CAA Environmental Assessment and Statement

Title of airspace change proposal	Land's End Transit Corridor (LETC)	
Change sponsor	Land's End Airport Limited (LEAL)	
Project no.	ACP-2019-075	
SARG project leader	[REDACTED]	
<p>Instructions</p> <p>In providing a response for each question, please ensure that the 'status' column is completed using one of the following options:</p> <ul style="list-style-type: none"> • yes • no • partially • n/a <p>To aid the SARG project leader's efficient project management, please highlight the "status" cell for each question using one of the three colours to illustrate if it is:</p> <p>resolved Green not resolved Amber not compliant Red</p>

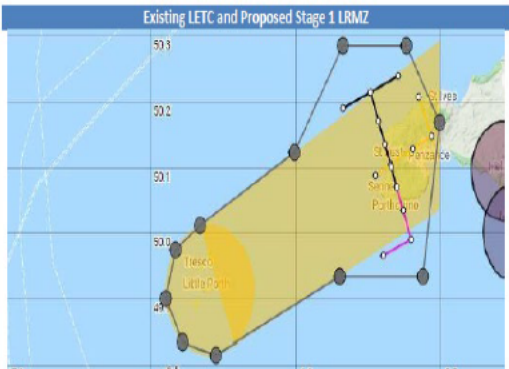
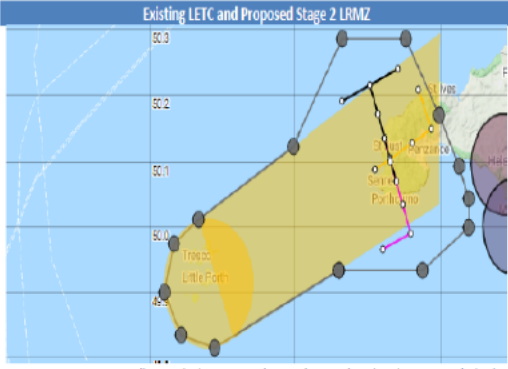
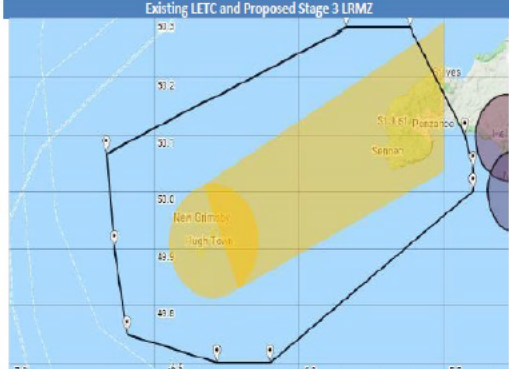
2. Nature of the Proposed Change		Status
2.1	Is it clear how the proposed change will operate, and therefore what the likely environmental impacts will be?	Yes
<p>This proposal seeks to reclassify the LETC as an RMZ, whilst redefining the LETC as the Land's End RMZ (LRMZ). Reclassifying the airspace as an RMZ will require aircraft transiting through the airspace to be radio equipped. In addition to this, the ACP seeks to change the shape of the LRMZ to include the instrument approaches at nearby aerodromes. The shape change would take place in three stages. The reason for these stages is because neither St Mary's nor Penzance have their published procedures as of yet and will be proceeding with their own ACPs to implement these. If these ACP's are approved by the CAA, the sponsor anticipates the shape change to take place in the following three stages, however, this order may be reversed and is subject to the outcome of both Penzance's and St Mary's ACPs:</p> <ul style="list-style-type: none"> • Stage 1 – Change the shape to include the IAP's at Land's End Airport. • Stage 2 – Change the shape to include the PINS approach at Penzance Heliport. • Stage 3 – Change the shape to include the IAP's at St Mary's Airport. <p>The figures below, extracted from the document '<i>Stage 4B Airspace Change Proposal v2.1</i>', illustrate the extent of the proposed LRMZ compared with the extent of current LETC, in addition to the shape changes related to each stage.</p> <div style="display: flex; justify-content: space-around;"> <div style="text-align: center;">  <p>Existing LETC and Proposed Stage 1 LRMZ</p> <p>Fig 2: Current LETC in yellow with the proposed LRMZ (Stage 1) outlined</p> </div> <div style="text-align: center;">  <p>Existing LETC and Proposed Stage 2 LRMZ</p> <p>Fig 3: Current LETC in yellow with the proposed LRMZ (Stage 2) outlined to now include the proposed PINS approach at Penzance</p> </div> <div style="text-align: center;">  <p>Existing LETC and Proposed Stage 3 LRMZ</p> <p>Fig 4: Current LETC in yellow with the proposed Land's End RMZ (Stage 3) in outline that includes approaches and holds at St Mary's, Land's End and Penzance.</p> </div> </div>

If this ACP were implemented, the vertical extent of the main portion of LRMZ would remain the same as it is currently; SFC to 4,000ft. The eastern land portion falls within the Culdrose Area of Intense Aviation Activity (AIAA) which extends vertically from SFC-6,000ft. The corridor falls within Class G airspace, however, there are two Aerodrome Traffic Zones (ATZs) at St Mary's and Land's End, both SFC – 2000ft and with 2NM radii. Neither Penzance nor Tresco heliports have an ATZ.

The overall shape of the proposed LRMZ, once all shape changes have occurred, will take into account the Instrument Approach Procedures (IAPs), and associated holds, at both St Mary's and Land's End Airport; the proposed PINS approaches at Penzance, in addition to the Visual Flight Rules (VFR) Northern Route from Land's End to St Mary's. The RMZ is proposed to coincide with the airport operating hours which vary during the summer and winter; "typical" summer hours are 0700-1730 UTC and "typical" winter hours are 0800-1730 UTC. Outside of these hours the airspace will revert back to how it operates today.

The CAA requested further clarification from the sponsor regarding the potential environmental impact as a result of the new portion of land that is to be encompassed by the proposed larger LRMZ, requesting whether this ACP will impact on aircraft that are currently using the airspace, or introduce any new flights to the airspace. The sponsor provided the following response:

"The majority of the size change happens over the sea and is proposed just to encompass the current IAPs at Land's End airport and the future IAPs at St Mary's airport and Penzance Heliport. Aircraft tracks over the sea are not expected to alter as the routing for aircraft will not be affected. Likewise, over the land portion of the LETC the proposed change will not affect aircraft routing and so there would be no change to the environmental impact of any future size change.

The alteration of the boundary of the LETC near Penzance is to encompass their proposed IAP and is only intended to provide a safety buffer zone around the IAP, which is almost entirely over the sea. It is not anticipated that moving the LETC boundary here would alter aircraft flight paths as the IAP has to be flown in accordance with the laid down procedure. Aircraft not using the IAP and routing from the Scillies would still follow their current tracks, again not having to be altered because of the boundary change. Traffic levels in this area would not be increased

<p>by the proposed change. The boundary to the north-east of the LETC, near St Ives, has actually been moved to reduce the land portion of the LETC thus reducing the environmental impact in this area".</p> <p>Therefore, in terms of the likely environmental impact it considered that there will be no impact as aircraft behaviours are unchanged, including those aircraft using the transit corridor and those using the IAPs at neighbouring airports. Due to the anticipated volume of impacted aircraft it is considered that any impact as a result of increased track mileage will be negligible. Although this ACP is anticipated to impact airspace design below 7,000 ft, it has been scaled as a Level 2C as the proposal does not expect to alter aircraft behaviours above or below 7,000 ft. Therefore, in accordance with the Department for Transport's (DfT) altitude-based priorities², the environmental priority is to reduce aircraft CO₂ emissions in support of the objective to ensure that the aviation sector makes a significant and cost-effective contribution towards reducing global emissions. Due to this being a Level 2C ACP, there is no explicit requirement for the sponsor to assess other environmental aspects, including impacts on local air quality, noise, tranquillity, and biodiversity.</p>
